Technical Note

Subject: **Fonthill Road Corridor – Design Amendments Pre/Post Planning**

The following technical note outlines the main changes to the proposed Fonthill Road corridor between the originally approved scheme and the final detail design.

Figure 1. Planning Layout – No Crossing Point

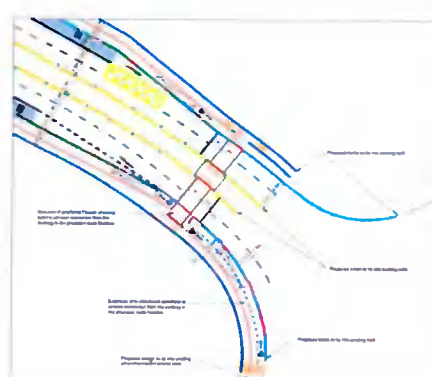
- 1.1. As one of the key objectives of the BusConnects guidance there is an emphasis on delivering safe cycling and pedestrian facilities along the corridor. As such, the proposed corridor from the outset included a number of toucan crossing points located at strategic areas of higher pedestrian/cyclist activity to cater for the envisaged movements to and from the Liffey Valley development and beyond to the wider road network.
- 1.2. The Stage 2 road safety audit undertaken for the design highlighted the issue of the transition between the existing bi-directional cycle provision at the southern tie in of the scheme and the proposed unidirectional cycle provision on both sides of the road along the corridor.

- 1.3. In order to overcome this conflict, the existing bi-directional cycle track was extended approximately 20m into the proposed scheme to tie in with a proposed new proposed toucan crossing beyond the north western exit from the existing roundabout. The rationale for inclusion of this design change was that this will remove ambiguity between the old/new cycle facilities and provide a needed connection from the single cycle track on the east side of Bóthar na Life to the existing bi-directional arrangement on the south west side.

Figure 3. Planning Layout – Staggered Crossing

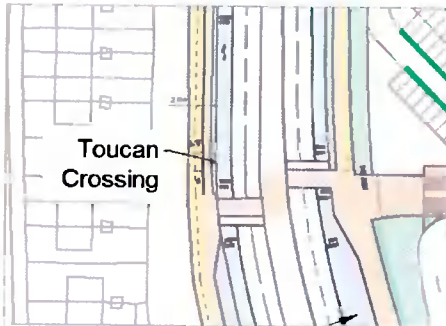
2.1. During the detailed design phase, the NTA instructed the design team to include 'straight across' pedestrian crossing points in line with the BusConnects guidance document paragraph 5.7, as opposed to 'staggered' pedestrian crossing points which were originally shown in the planning layouts.

2.2. Following discussions with the NTA and SDCC on the matter it was recognised that this type of arrangement is commonly implemented nationwide, and given that there are examples of 'straight across' type crossings currently in place in and around Dublin, agreement was reached on the inclusion of this type of crossing throughout the corridor.

Figure 7. Proposed Layout – In Line Bus Islands (South)

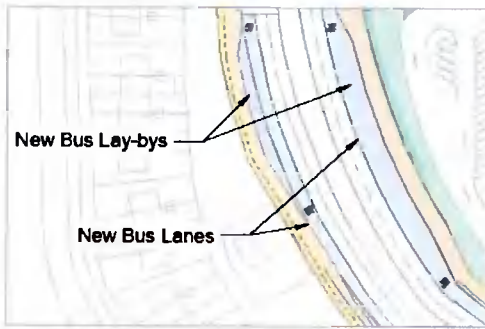
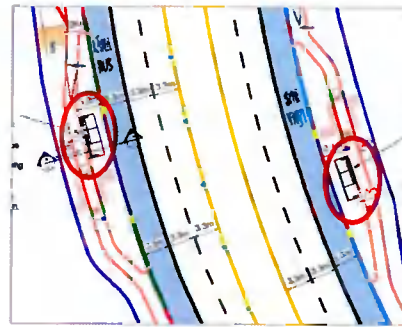
3.1. The initial layout provided for inset bus layby's at bus stops along the perimeter road. However early on in the design process the NTA confirmed that only in-line bus stops (i.e. no inset bay) are required at the south west section of the corridor as per the BusConnects guidance document paragraph 11.1 and Figure 5 extract.

3.2. It should be noted that 2 no. new bus shelters are being proposed in this location (1 no. on each side of the road) as denoted on Figure 7 above. Each shelter shall include 1 no. mounted RTPI unit and 1 no. advertisement box and be as per JCDecaux drawings TEL-B653-SK-013A 'Reliance Shelter – 3 Bay Reliance Mark' included for information as part of the application drawing pack.

Figure 9. Proposed Layout – In Line Bus Island (South)

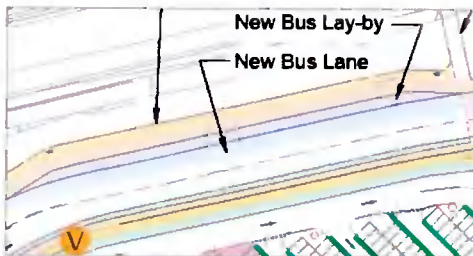
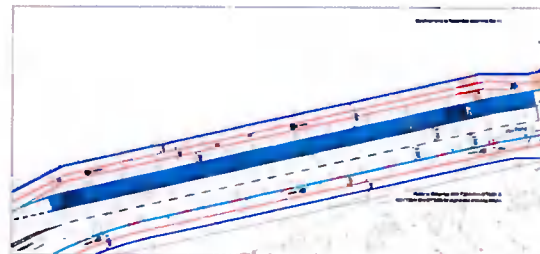
3.3. This type of 'in line' bus stop arrangement has also been replicated to the north of the shopping centre adjacent to the existing N4 footbridge as per Figures 8 and 9 below. The NTA however confirmed that this area is only intended as a 'set down' area for users exiting the buses and therefore will not require bus waiting areas/shelters.

Figure 11. Proposed Layout – Removal of Left Slip with Additional Bus Priority

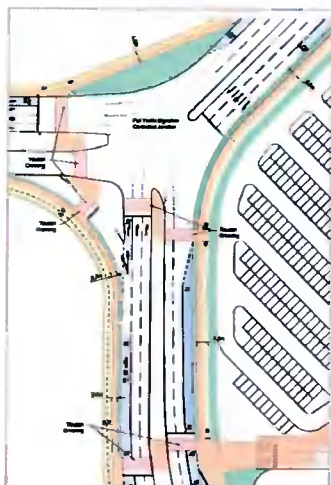
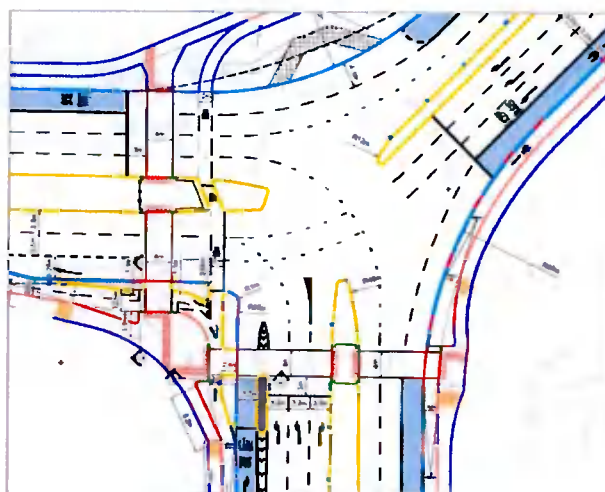
- 4.1. The original planning layout assumed retaining the existing segregated left slip lane on the southern arm of the proposed signal junction for vehicles wishing to travel westbound along Bóthar na Life. Following new design criteria set out within the BusConnects guidance document, the NTA requested that Systra undertake a review of bus priority at the signal junction in addition to removing the left slip lane.
- 4.2. Following a process of re-design of the southern arm of the junction in addition to further modelling work being undertaken to assess the optimum layout from a traffic perspective, the layout in its current format was accepted by the NTA and SDCC.
